## THE ROYAL HOSPITAL FOR CHILDREN AND YOUNG PEOPLE, EDINBURGH

### Key Issues Report No. 42 September 2018

<b>Site:</b>	Royal Hospital for Sick Children and Department of Clinical Neurosciences and Child and Adolescent Mental Health Services – Little France	
<b>Report:</b>	Independent Tester Key Issue Report No 42	
<b>Date:</b>	04/10/18	
<b>Present:</b>	<div style="background-color: black; width: 100px; height: 15px; margin-bottom: 5px;"></div> <div style="background-color: black; width: 100px; height: 15px; margin-bottom: 5px;"></div> <div style="background-color: black; width: 100px; height: 15px;"></div>	<b>Arcadis</b>  <b>Arcadis</b>  <b>Arcadis</b>

**Appendix A – Example Photographs  
September 2018**

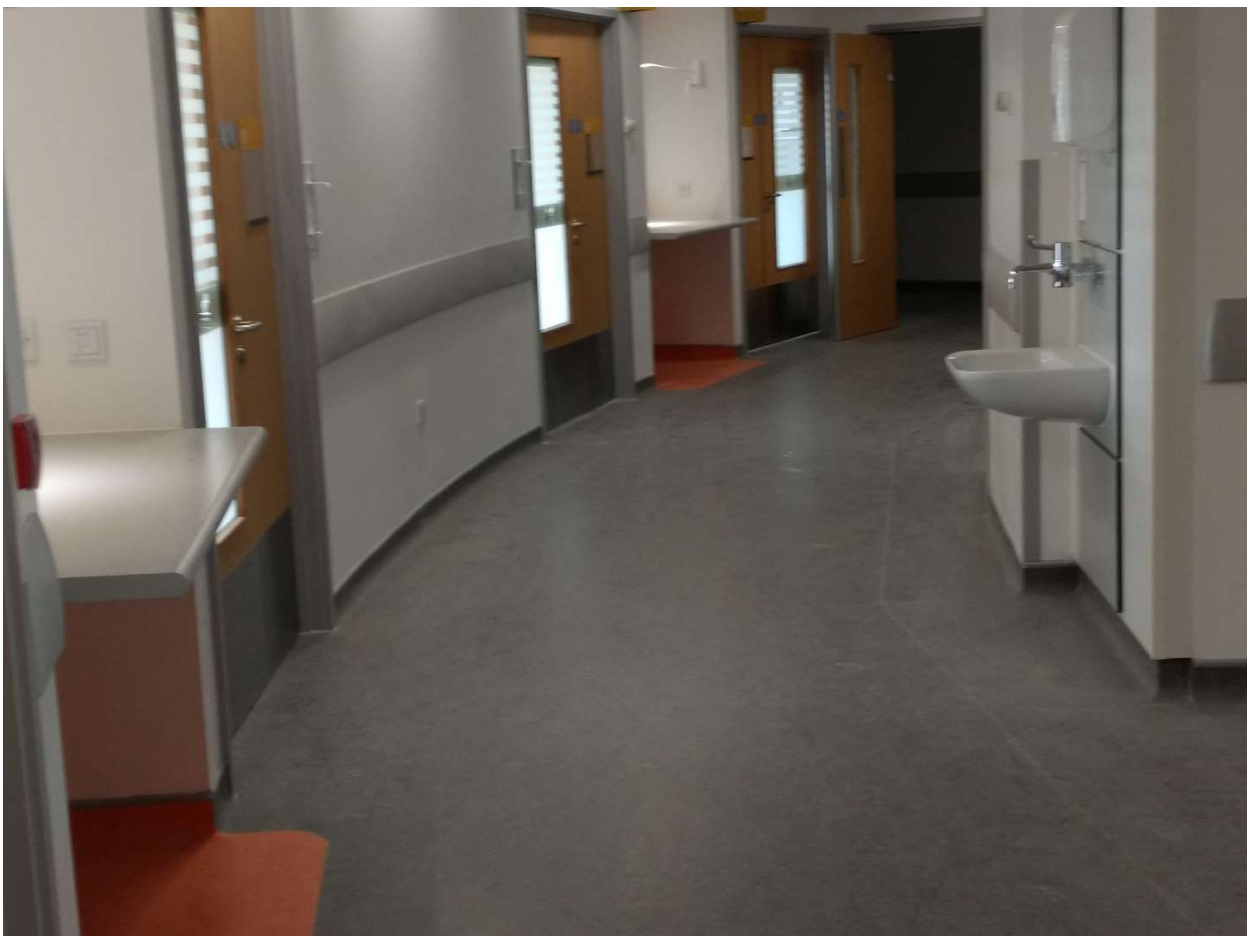
1 – Very noticeable batch variations between rooms – Dental room

2 – Fence / hedge gate position allowing clear view to PICU

3 – Evidence of damp proofing requiring QA

3 - Obstructions in corridors as CIT 229 and Zutec 19973

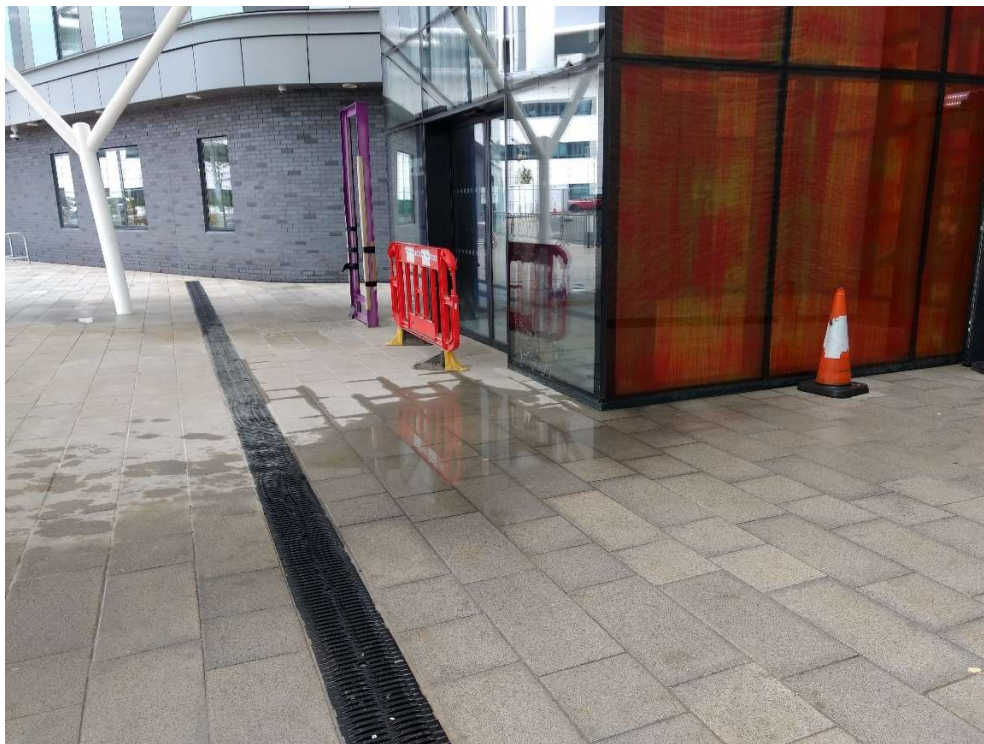
4 – Extent of replacement slabs to main entrance

6 – Numerous trees have sustained wind damage

7 – Heavy machinery operating on paved areas without adequate weight spreaders

8 – Areas of ponding either side of main entrance – CIT196
